Project name:
NDEP

Technical Memorandum

Subject: RI Modification: Supplemental Surface Water Investigation Plan

AECOM **Figure 3**

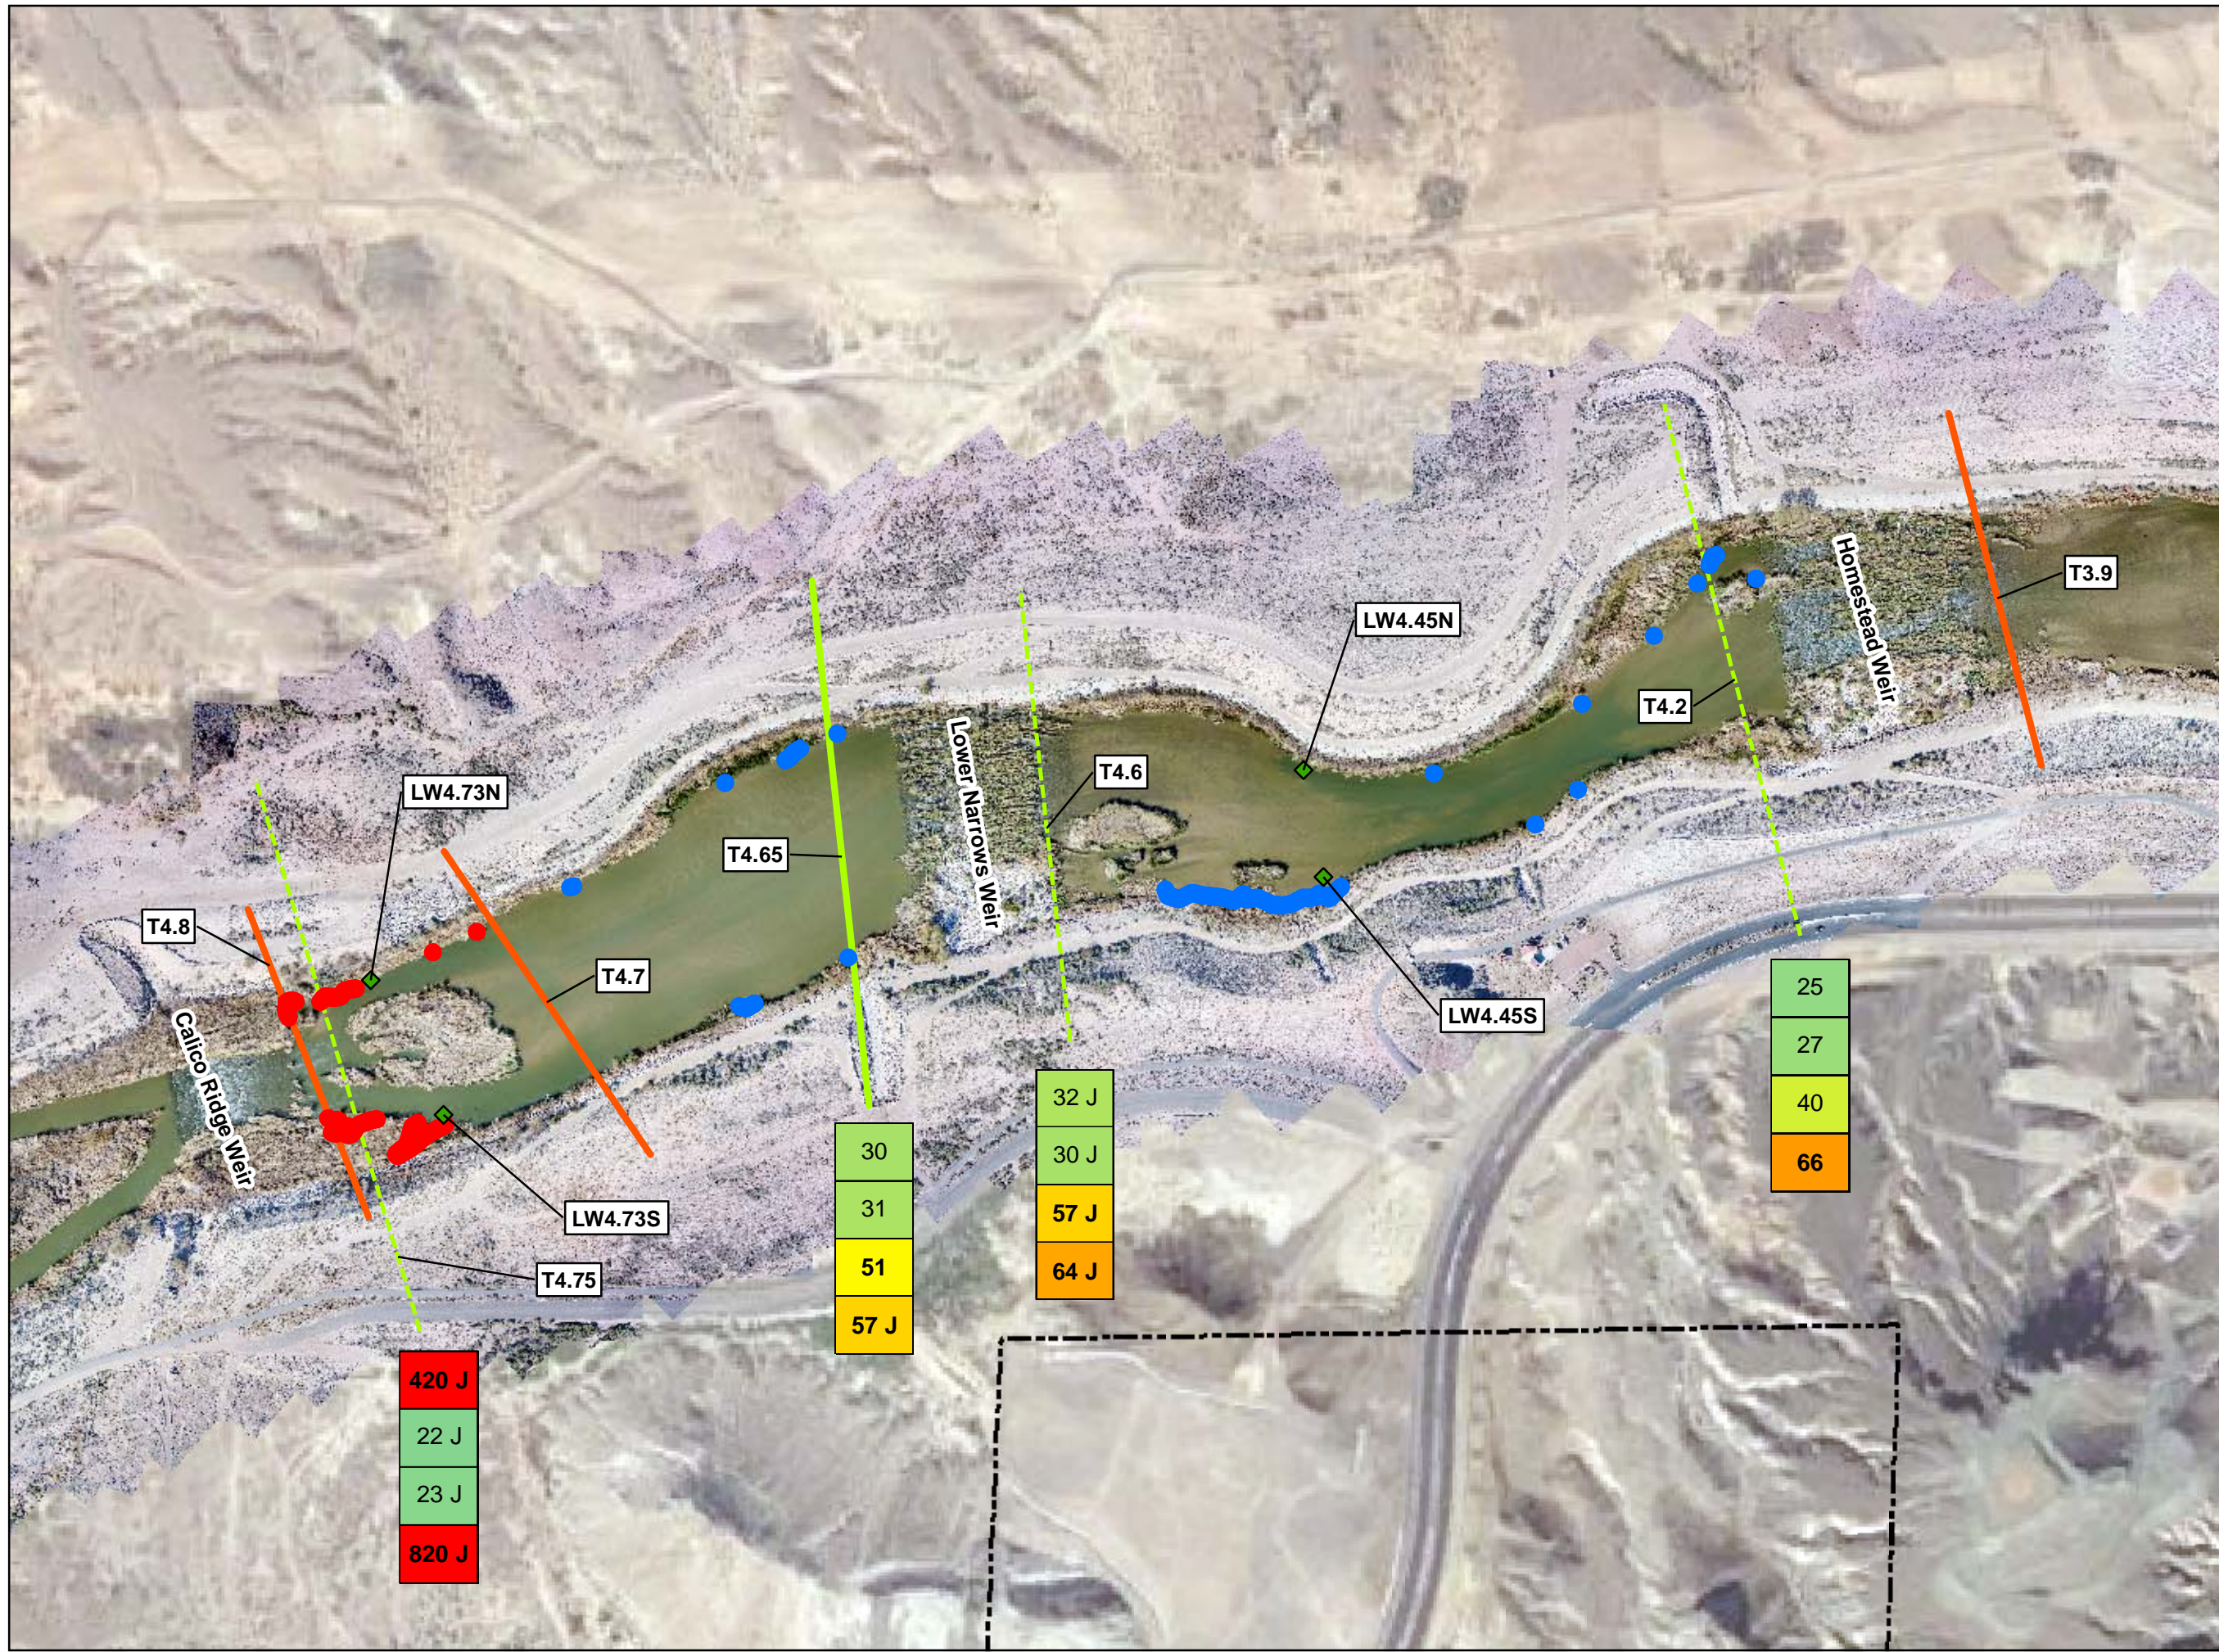
Upper Narrows Weir to Sunrise Mountain Weir - **Figure 3** shows the proposed revised sample locations from Upper Narrows Weir to Sunrise Mountain Weir construction zone.

- The two transects added (T6.55 and T6.5) were placed through the warm anomaly and downstream of the anomalies (upstream of the construction zone).
- Transect T6.35 is removed because its proposed location is within the construction zone.
